**APPENDIX B**

## AP1000 CORE REFERENCE REPORT DCD (Rev. 19) Change Road Map

### General Non-LOCA Change Summary

Figure 15.0.3-2

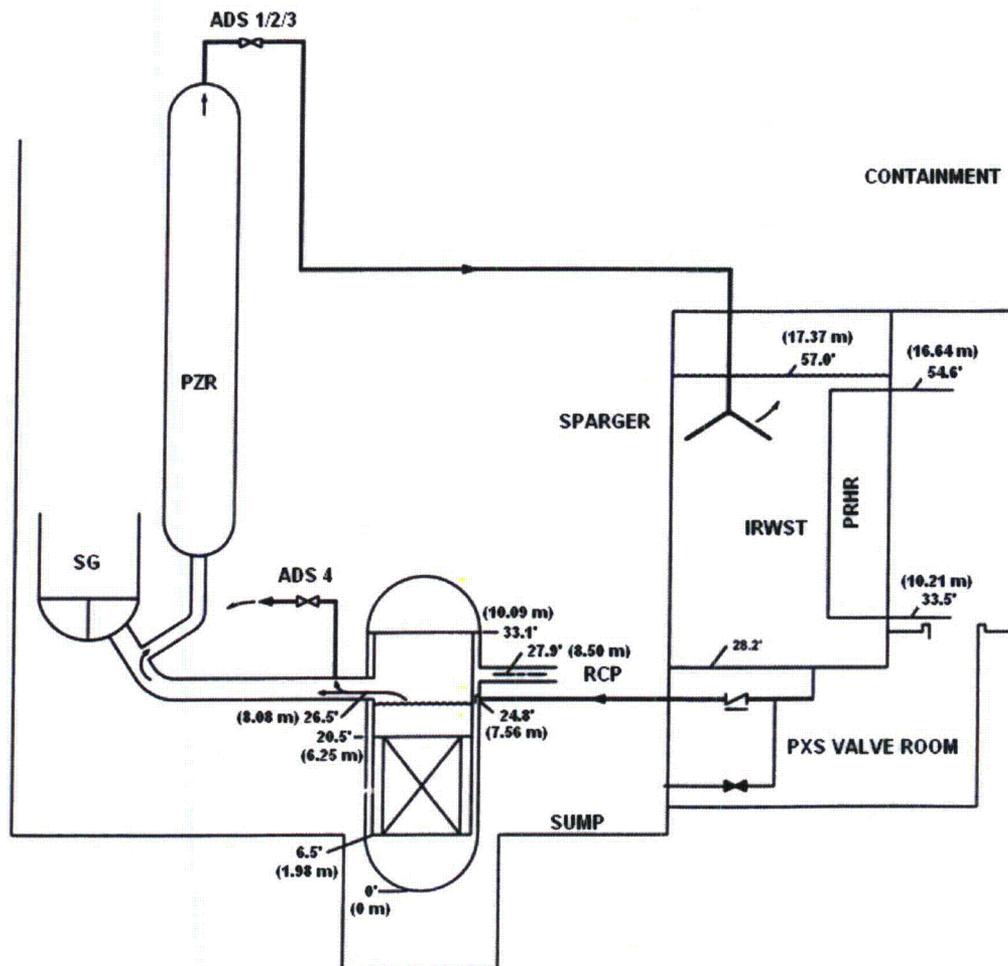
Comment [B53]: 15.0-53

Figure 15.0.4-1

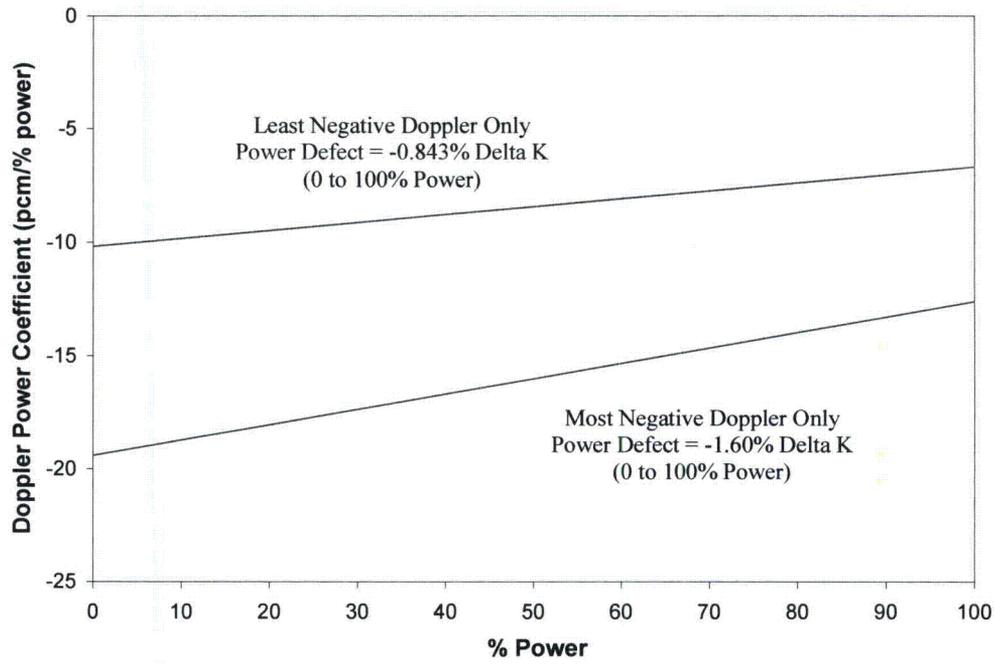
Comment [B54]: 15.0-54

Figure 15.0.5-1

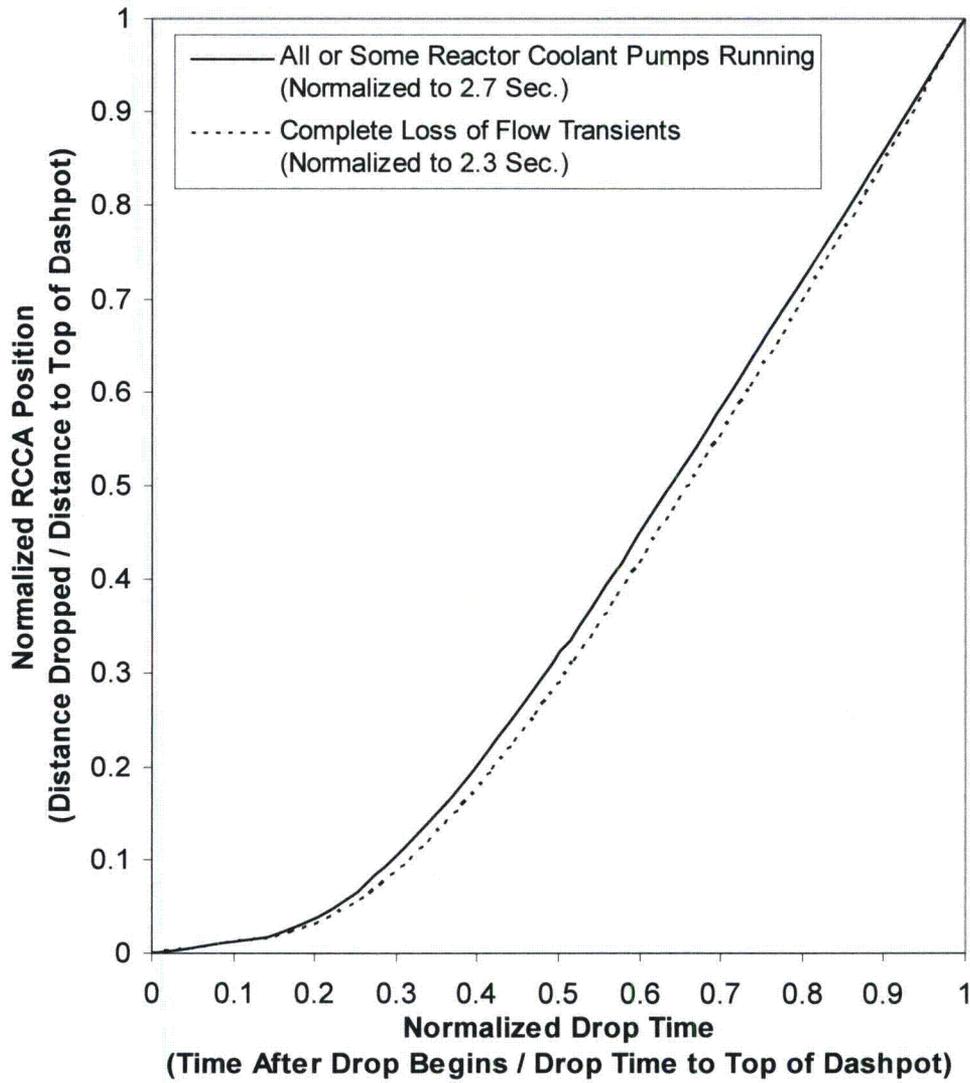
Comment [B55]: 15.0-55

Figure 15.0.5-3

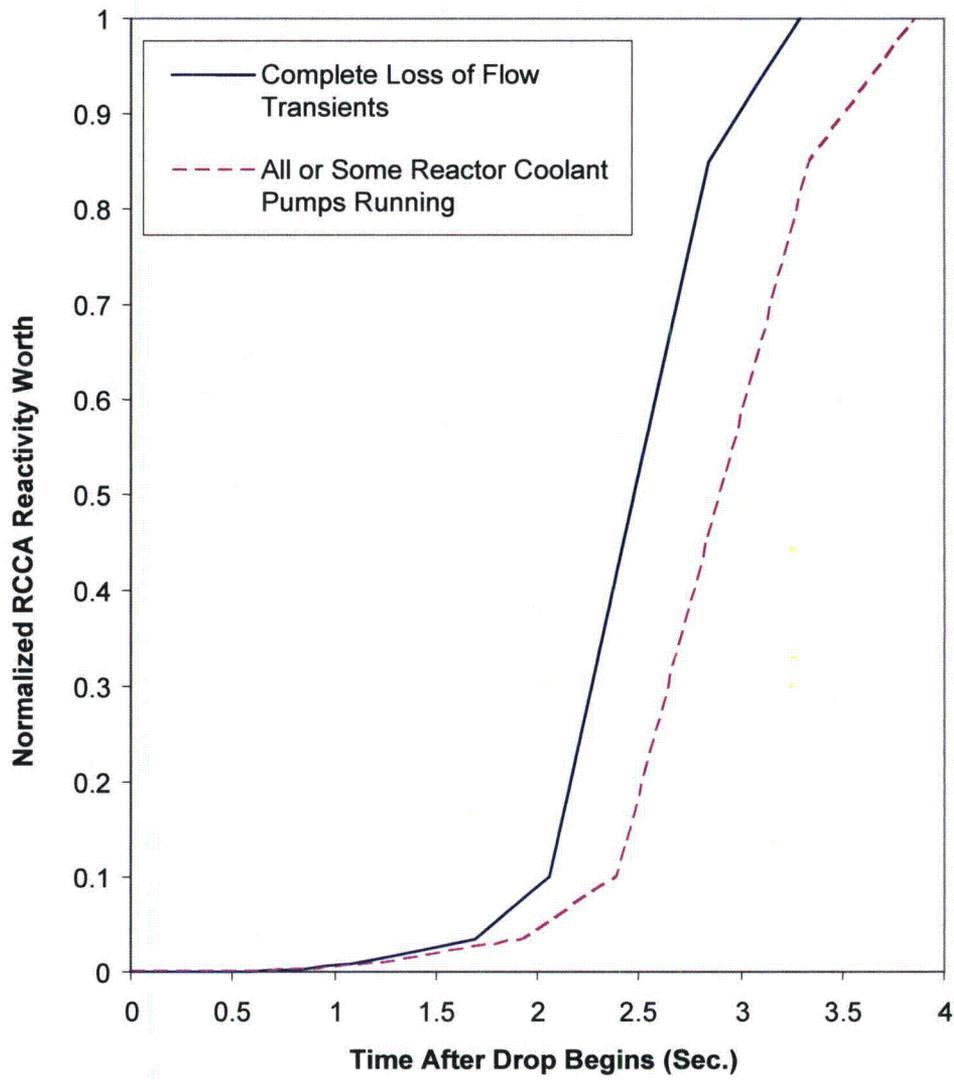
[15.0-56]	Figure 15.0.5-3	This figure reflects the revised rod insertion curve, updated for the new rod drop times, modeled in the Chapter 15 analyses for the AFC design.
[15.0-57]	Table 15.0-2 (Sheet 5 of 5)	This table has been updated consistent with the response provided to CRR-008.
